RE: NWB Technical Review of the 2021 Annual Report for the Meliadine Project; Water Licences Nos: 2AM-MEL1631 and 2BB-MEL1424

The following information and comments are intended to address comments outlined in the following letter: **220819 2AM-MEL1631 2021 Annual Report Review-OSKE**.

Figure 1. Orthophosphate concentrations (mg/L) in Meliadine Lake from 1997 to 2021.

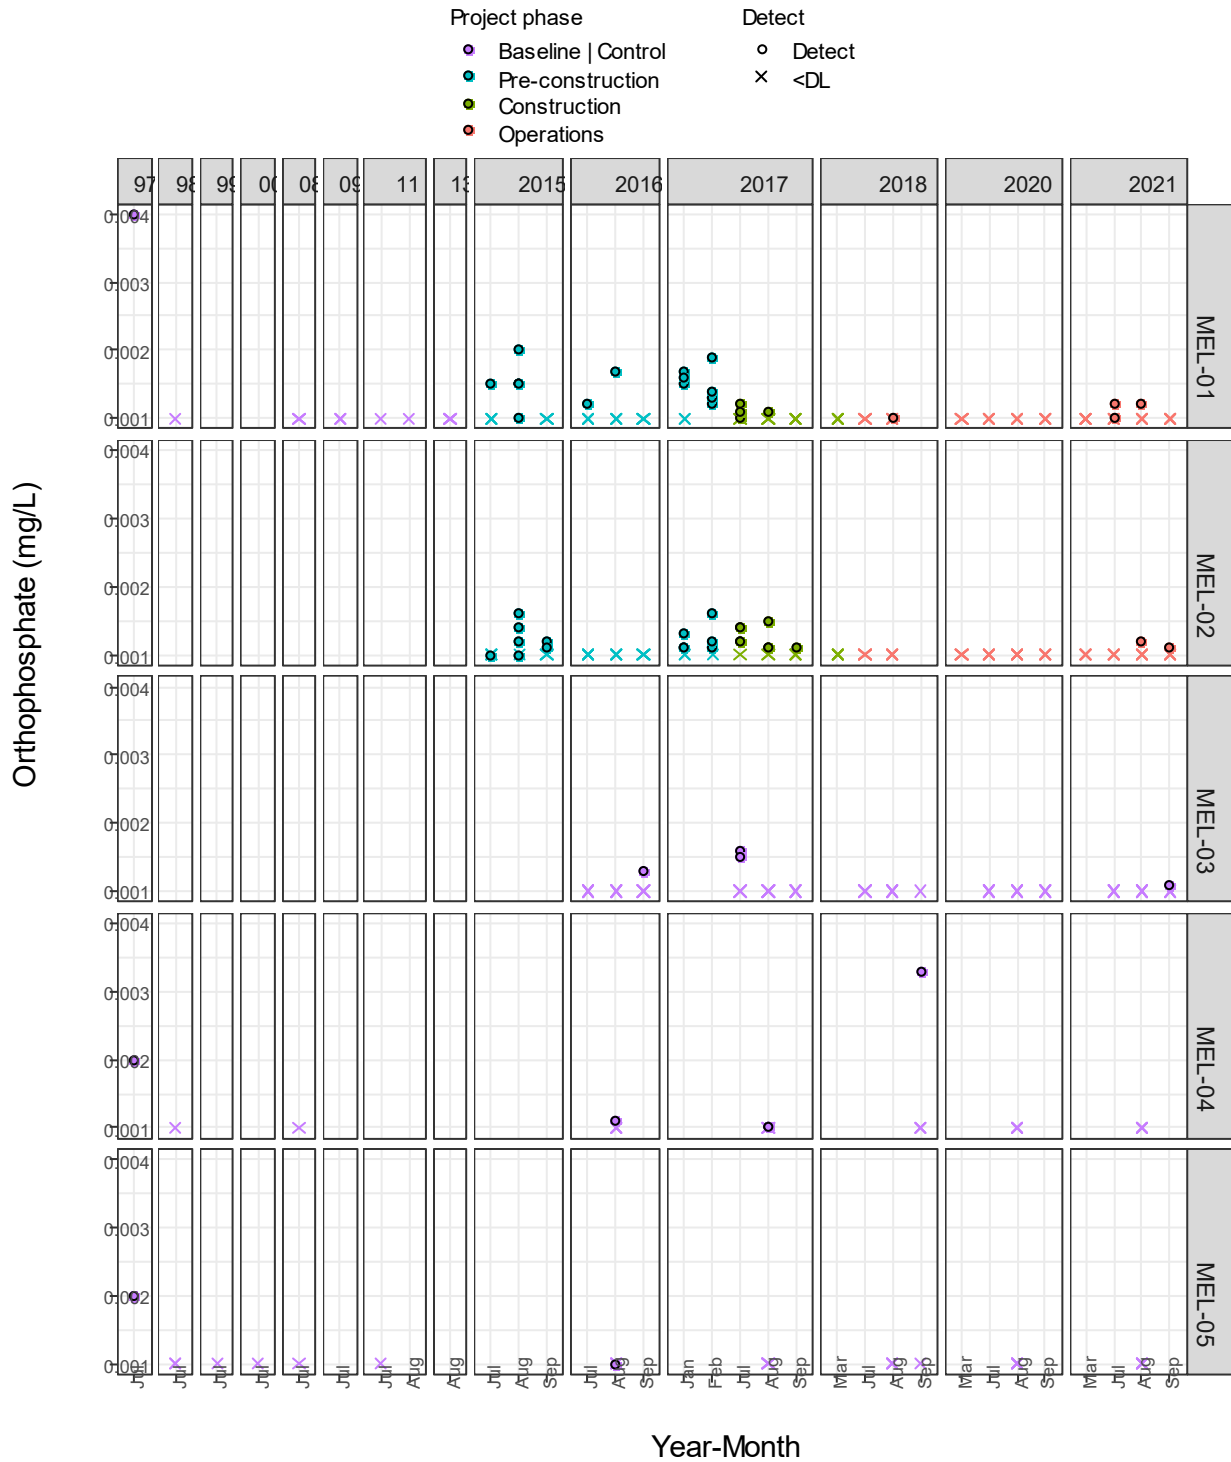
- Amend the statement in Section 7.1.4 to acknowledge that phosphorus concentrations have increased over time in the East Basin of Meliadine Lake
- Explore strategies to mitigate the impact of nutrient enrichment in the East Basin, including, but not limited to, increasing the volume of contact water diverted to Itivia Harbour.

As per 2021 Annual Report Answers provided to the NIRB on July 27th, 2022 (KivIA-13), total phosphorus concentrations have, in general, increased since the baseline period from the lower end of oligotrophic status (0.004 mg/L) to near the AEMP Action Level of 0.0075 mg/L. There is, however, some uncertainty about the natural range in phosphorus concentrations in Meliadine Lake given sparse and highly variable data collected during the baseline period (Figure C2-23). In 1997, the concentration reported in the East Basin (MEL-01) in July was at the upper limit of oligotrophic status (0.01 mg/L). Furthermore, phosphorus concentrations have periodically exceeded the upper limit of oligotrophic status at the reference areas. For example, phosphorus was measured at 0.03 mg/L in the samples taken in the Northwest Basin (MEL-04) in July 1997. Near the outlet of Meliadine Lake to the Meliadine River (MEL-05), 5 of the 7 samples collected in July from 1997 to 2011 had phosphorus concentrations that were equal to or greater than the AEMP Action Level. On a lake-wide basis, phosphorus concentrations have typically measured within the range of oligotrophic status (0.004 mg/L to 0.01 mg/L), but the use of 75% of the upper limit of oligotrophic status as the AEMP Action Level means we can likely expect periodic exceedances of the AEMP Action Level at MEL-01 in the future. It's important to emphasize that phosphorus loadings decreased significantly after the sewage treatment plant at the main camp came online in November 2017.

Based on the available data from water chemistry and phytoplankton monitoring programs, the concentration of total phosphorus in water samples is a relatively weak line of evidence for deciding if effluent is causing nutrient enrichment and effects to primary productivity. Phytoplankton community endpoints such as total biomass and chlorophyll-a are a better indicator of whether effluent is causing nutrient enrichment and effects to primary productivity. As mentioned in Section 7 of the 2021 AEMP report (Phytoplankton), phosphorus and nitrogen concentrations in surface water do not appear to be strongly influencing phytoplankton biomass or chlorophyll-a based on data collected at the NF, MF, and reference areas in Meliadine Lake since 2013 (Figure 6 9). Most of the phosphorus in freshwater occurs as organic phosphates, cellular constituents of organisms, and within or adsorbed to inorganic and dead particulate organic matter (Wetzel 2001). Among the various chemical forms of phosphorus in freshwater systems, orthophosphate is the only form of soluble inorganic phosphorus directly utilized by

aquatic biota¹. Challenges with accurately estimating orthophosphate, combined with rapid turnover, means total phosphorus is typically recommended as the default parameter to include in monitoring programs. Nonetheless, orthophosphate concentrations at the near-field and mid-field exposure areas are typically below the limit of detection (see figure below). Orthophosphate was more routinely detected at MEL-01 and MEL-02 from 2015 to 2017 before sewage from the Exploration Camp was diverted to the sewage treatment plant at the main camp.

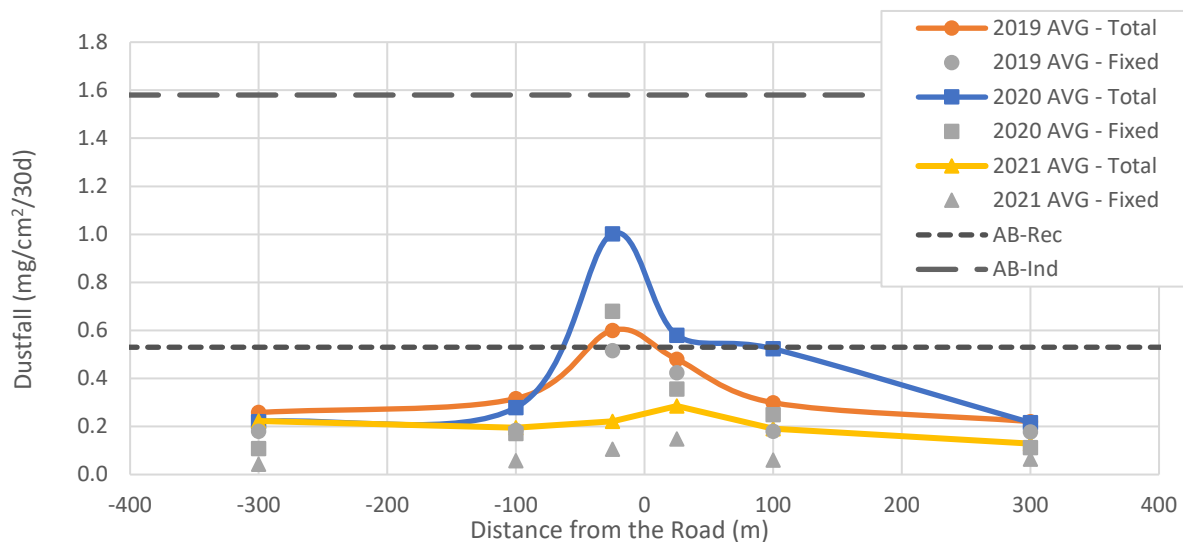
Assess the impact of the heavier 2021 summer precipitation on the reduced rate of dustfall.

As per 2021 Annual Report Answers provided to the NIRB on July 27th, 2022 (ECCC-9), Agnico Eagle appreciates and agrees with ECCC's comment that precipitation may have also influenced road dust generation in 2021. Agnico Eagle understands that in fact, many environmental factors such as precipitation, temperature, and wind speed can influence rates of fugitive dust, in combination with use scenarios, road material, and dust suppressant application. For clarity, the objective of this report with regards to road dust is to document current conditions and trends in measured dustfall, and indicate the best management practices that are in place to help minimize dust generation. While a basic commentary on potential reasons for observed trends is provided, Agnico Eagle notes that rates of dustfall are assumed due to a complex interaction of the above-mentioned factors. These factors have well-established relationships used in air quality modelling, and any validation of those relationships is beyond the scope and design of this monitoring program.

Nevertheless, Agnico Eagle has conducted a basic review of summer precipitation rates in relation to dustfall results since 2019 when roadside transect sampling began. Precipitation recorded by the Rankin Inlet weather station was reviewed, since automated precipitation monitoring didn't begin at Meliadine until 2020. As ECCC indicates in their comment, total summer precipitation in 2021 was greater than 2020 (Table 1), which in isolation would lead to a reduction in fugitive dust year-over-year. However total precipitation in 2019 was greater than 2020 and 2021, yet measured average dustfall was not lowest in 2019 (Figure 1), indicating that, as would be expected and discussed above, other factors also have an important impact on dust generation.
